Middels dit bulletin willen wij informeren dat er een wijziging op de Ditting molens wordt doorgevoerd

**Stationary disc flange Art.No. 1008708**

| Oude versie                                                                        | Nieuwe versie                                                                       |

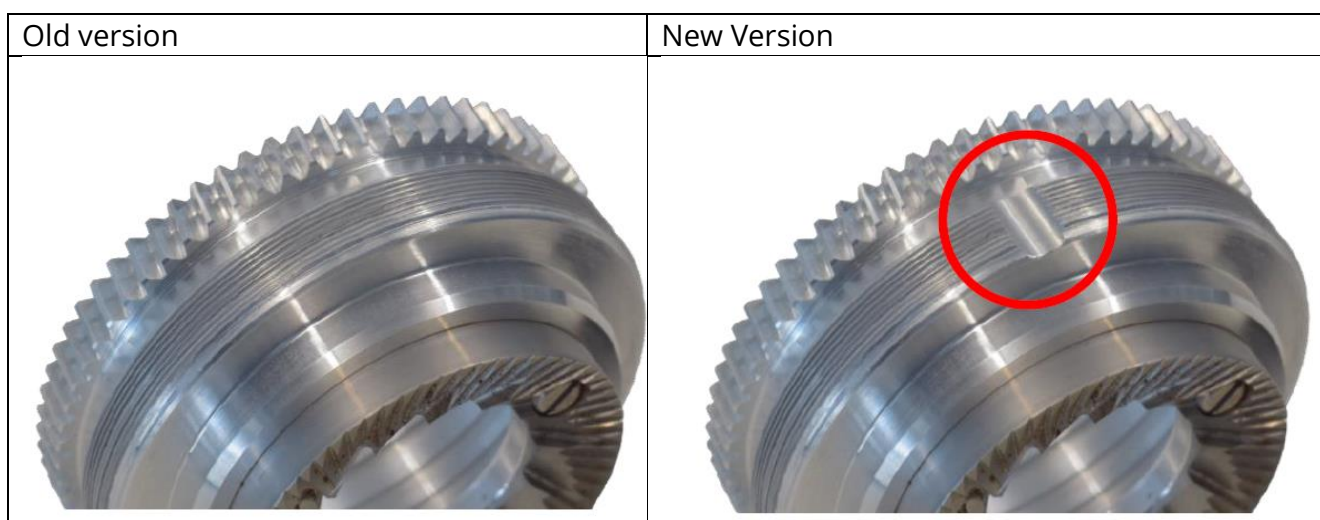
De bovenste stationaire flens van de molen is aangepast. De maalschijven zijn als apart onderdelen te bestellen met artikelnummer 1005606.

De belangrijkste wijziging en verbetering van deze flens is:

- Een groef in de draad van de flens (ze foto)
- Minder vastlopen van de flens door vervuiling

The main improvement of the stationary disc flange is:

- Dirt groove in the thread
- Less jammed flanges

De flens is volledig backwards compatible.

The adapted Ditting stationary disc flange is fully backwards compatible. Existing spare parts on stock (old version) can be still used for all machines.

This change will be implemented from **CW16/2019**.
